## Product Change Notice (PCN)

PCN Number: PCN-0451162R-01

Product(s) Affected: PJ-040CH

PREVIOUS CUI DEVICES DETAIL / IMAGE	NEW CUI DEVICES DETAIL / IMAGE

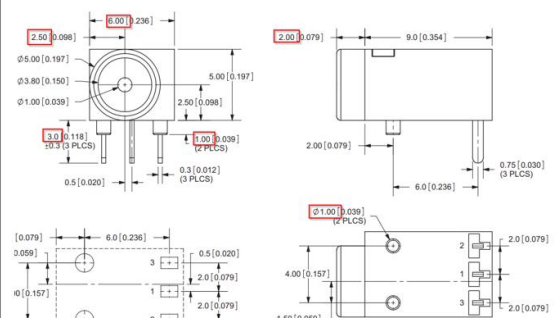
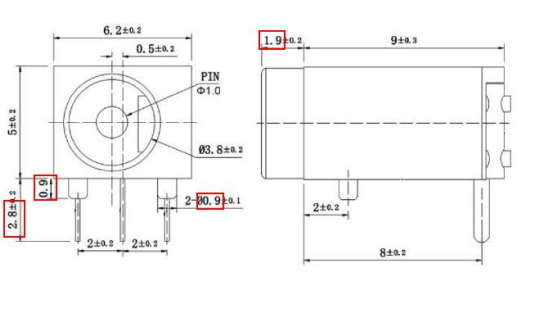
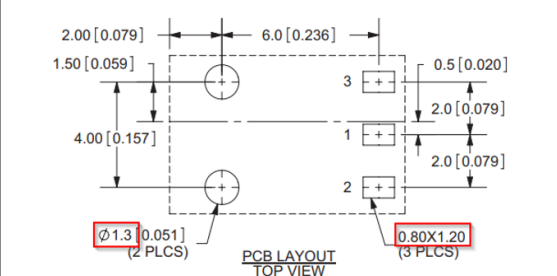
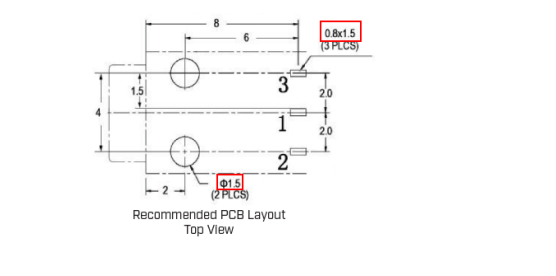
Description of Change: mechanical, material differences as shown below:

<p>PCB LAYOUT TOP VIEW</p>	 <p>Recommended PCB Layout Top View</p>																																							
<table border="1"> <thead> <tr> <th></th> <th>MATERIAL</th> <th>PLATING</th> </tr> </thead> <tbody> <tr> <td>center pin</td> <td>brass</td> <td>silver</td> </tr> <tr> <td>terminal 1</td> <td>brass</td> <td>silver</td> </tr> <tr> <td>terminal 2</td> <td>copper alloy</td> <td>silver</td> </tr> <tr> <td>terminal 3</td> <td>brass</td> <td>silver</td> </tr> <tr> <td>plastic</td> <td>PA66</td> <td></td> </tr> </tbody> </table>		MATERIAL	PLATING	center pin	brass	silver	terminal 1	brass	silver	terminal 2	copper alloy	silver	terminal 3	brass	silver	plastic	PA66		<table border="1"> <thead> <tr> <th>DESCRIPTION</th> <th>MATERIAL</th> <th>PLATING/COLOR</th> </tr> </thead> <tbody> <tr> <td>center pin</td> <td>brass</td> <td>silver</td> </tr> <tr> <td>terminal 1</td> <td>brass t=0.25</td> <td>silver</td> </tr> <tr> <td>terminal 2</td> <td>brass t=0.25</td> <td>silver</td> </tr> <tr> <td>terminal 3</td> <td>brass t=0.25</td> <td>silver</td> </tr> <tr> <td>cover</td> <td>PBT (UL94V-0)</td> <td>black</td> </tr> <tr> <td>housing</td> <td>PBT (UL94V-0)</td> <td>black</td> </tr> </tbody> </table>	DESCRIPTION	MATERIAL	PLATING/COLOR	center pin	brass	silver	terminal 1	brass t=0.25	silver	terminal 2	brass t=0.25	silver	terminal 3	brass t=0.25	silver	cover	PBT (UL94V-0)	black	housing	PBT (UL94V-0)	black

MATERIAL	PLATING																																						
center pin	brass	silver																																						
terminal 1	brass	silver																																						
terminal 2	copper alloy	silver																																						
terminal 3	brass	silver																																						
plastic	PA66																																							
DESCRIPTION	MATERIAL	PLATING/COLOR																																						
center pin	brass	silver																																						
terminal 1	brass t=0.25	silver																																						
terminal 2	brass t=0.25	silver																																						
terminal 3	brass t=0.25	silver																																						
cover	PBT (UL94V-0)	black																																						
housing	PBT (UL94V-0)	black
